RE: RESPONSE TO A THIRD-PARTY APPEAL IN RESPECT OF A PROPOSED MIXED-USE DEVELOPMENT INCORPORATING OFFICE, ARTS / CULTURAL / COMMUNITY USE AND RETAIL / CAFÉ / RESTAURANT AT 1 NORTH WALL QUAY, DUBLIN 1, D01 T8Y1.

DUBLIN CITY COUNCIL REG. REF.: 3274/24

AN BORD PLEANÁLA REF.: ABP-319719-24

Figure 2.1: Sections of Surrounding Buildings assess at Application Stage

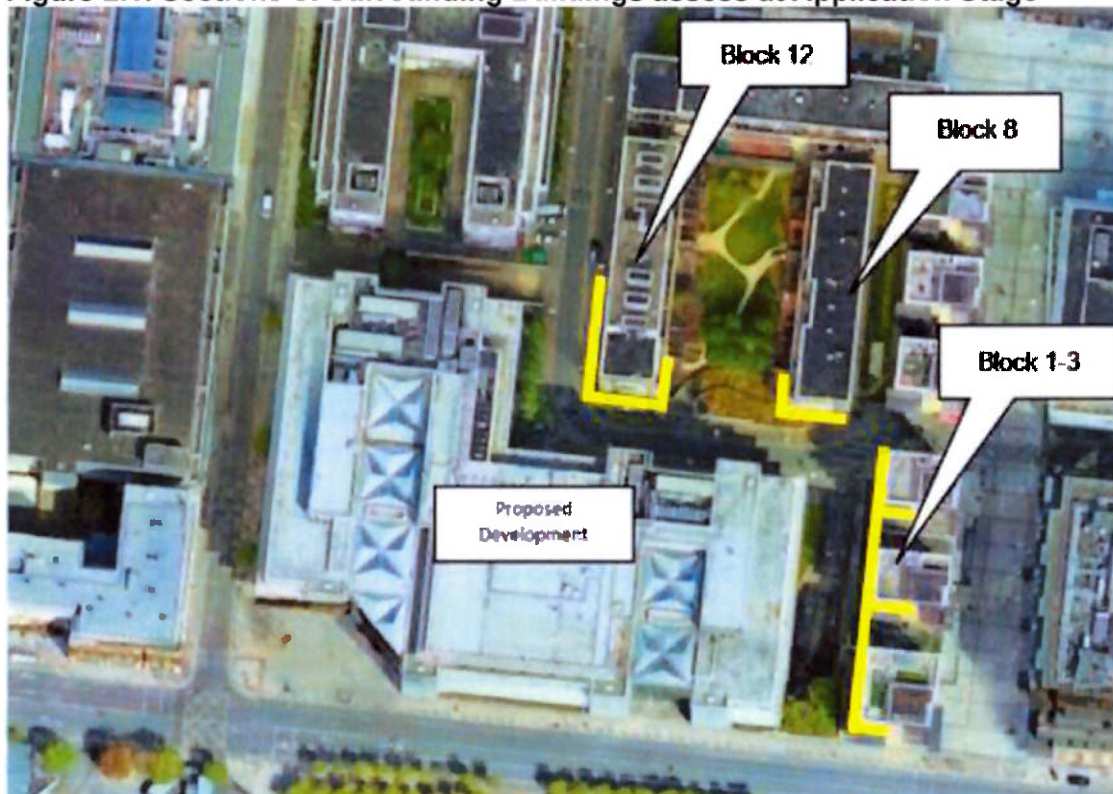
"The proposed redevelopment of the CitiGroup building would effectively negate all these aspects of this award-winning housing development. The Sunlight and Daylight Report submitted in support of the application contains minimal analyses of the effects on the CQE which the Planning Authority clearly states were deficient. The Dublin city planners had requested at the Pre-planning meeting that a full study was undertaken due to their concerns about the harm that the proposed development would do to the residents and the amenity of CQ Estate due to its height and massing. This constituted overbearing, overshadowing and the loss of light inter ilia."

"Further, the windows of the blocks analysed are limited to the nearest section of the building to the site and do not include the existing balcony areas including those adjacent the amenity area which are likely to be affected by the proposed development. The Applicant has not provided a comprehensive analysis as was requested at the pre application consultation meeting. All windows fronting the amenity space including balconies which will be affected by the proposed development should have been assessed. This concern has also been raised by residents of the Clarion Quay apartments who believe they will be severely negatively affected in terms of loss of daylight, sunlight and overshadowing by the proposed development."

A Daylight, Sunlight and Overshadowing Assessment was prepared by BPC Engineers and submitted at application stage. The report assessed the southern apartments in Blocks 8 & 12 and the western facing apartment in Blocks 1-3 as illustrated below:

An additional assessment was prepared by BPC Engineers in response to the assessment of the application by the City Council and submissions on the application and was submitted as Appendix 7 of the 1st party appeal document. The document assessed windows fronting the amenity space including balconies and states the following in relation to daylight:

Figure 1 – Autotracking of Service Vehicle

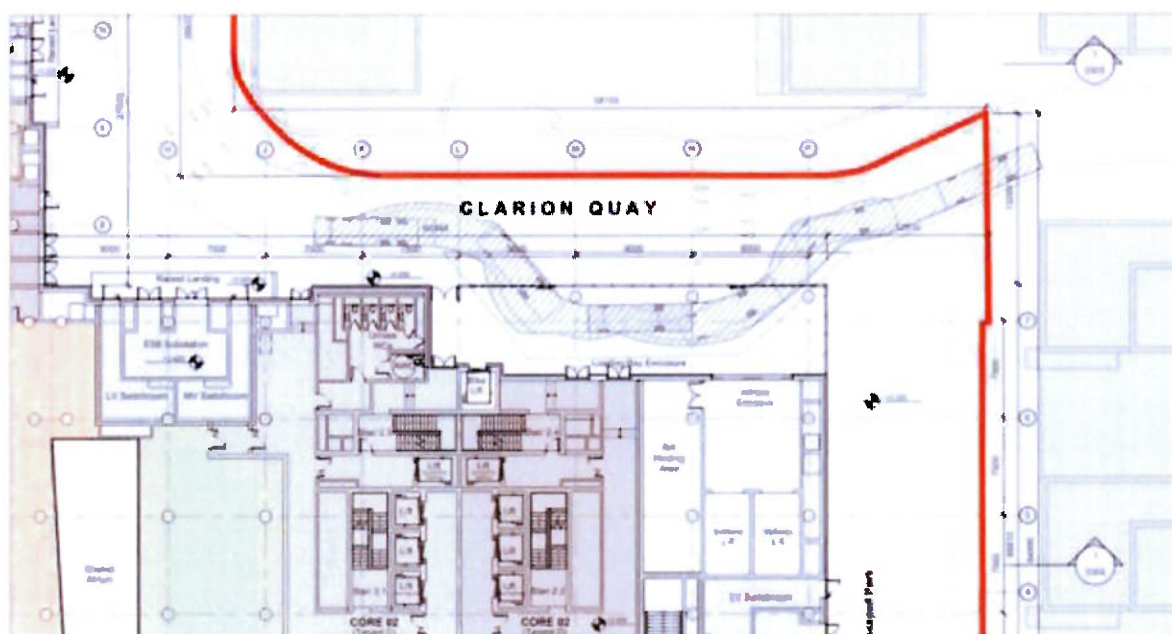
The appellant states that *"as the building will potentially accommodate multiple office users, the Gaiety School of Acting and the visitors to the Liffey Experience, we are concerned that the service and delivery access is not sufficient for the building as proposed and would not withstand future demand as outlined."*

"As outlined in the 1st-party appeal submission, the proposed development's vehicular servicing arrangements maybe modified by condition through the provision of a loading bay enclosure off Clarion Quay, within the building curtilage. This would ensure that servicing vehicles have a clearly defined, secure area within which to stop, and prevents obstruction of the Clarion Quay carriageway and footpath. See Henry J. Lyons architectural drawing no. 1NWQ-HJL-AX-00-DR-A0100 for details. An extract of drawing 1NWQ-HJL-AX-00-DR-A-0100 is included in Figure 1 below outlining the autotracking of a servicing vehicle entering the proposed designated service area.

The 2no. parking spaces shown on Clarion Quay in the initial planning submission maybe modified by condition to another external loading bay/set-down area for refuse collection and taxi drop off facilities, etc. We note that the refuse staging area would be adjacent to this potential loading bay, providing off road temporary parking for refuse vehicles on Clarion Quay and preventing the obstruction of other traffic along Clarion Quay.
